Crossland Strategic Metals Limited
(ABN 64 087 595 980)

Variation to 2018 Mine Management Plan Drilling Programme

Figure 1, 2018 approved drilling programme at Cattle Creek

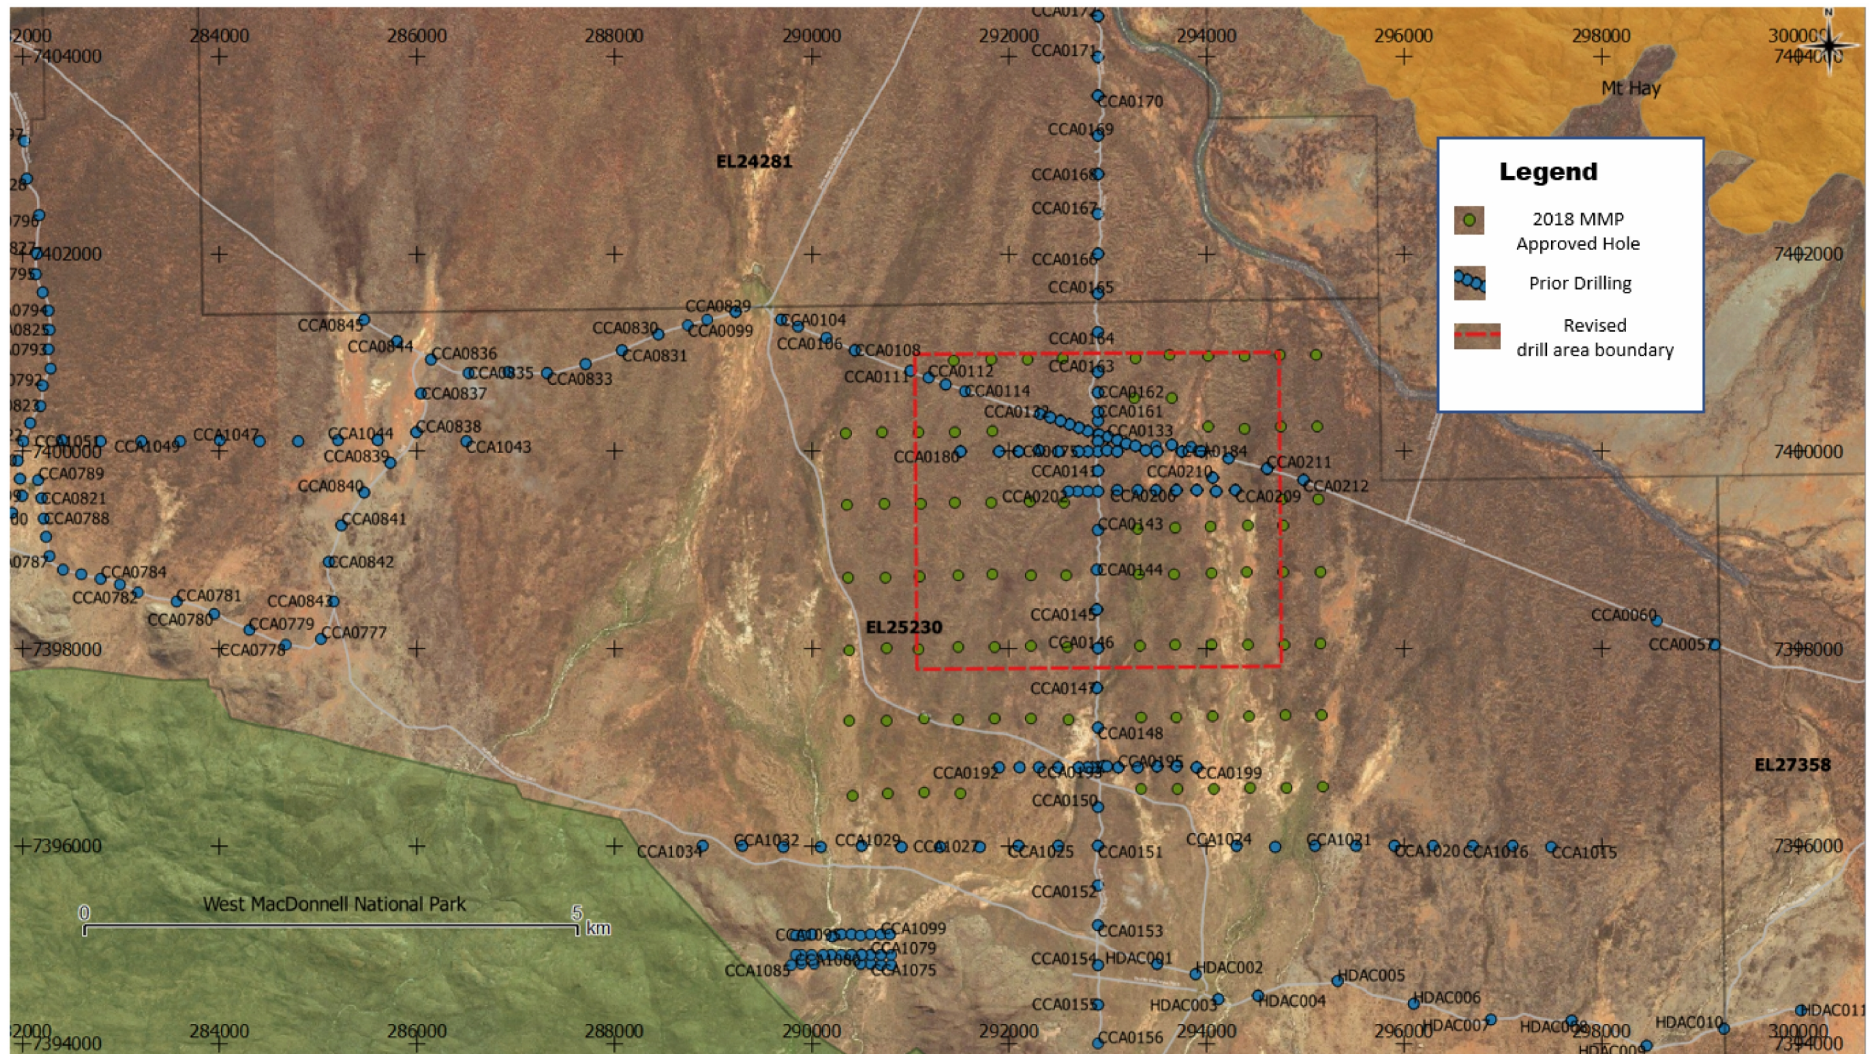
The current approved plan had planned 84 air-core holes drilled on a grid spacing of 800m (north-south) x 400m (east-west) on EL25230 in the Cattle Creek area. We will be reducing the area significantly from planned but increasing the density of drilling to 105 holes but still within the prior drilling foot-print. The planned grid spacing will be 400m (north-south) x 200m (east-west) in the same Cattle Creek area. Refer to Figure 1 for a plan illustrating the approved drilling programme, existing holes and revised drilling area.

Proposed new drill area shown in red (containing 105 holes , <65m in depth, position of holes not shown)
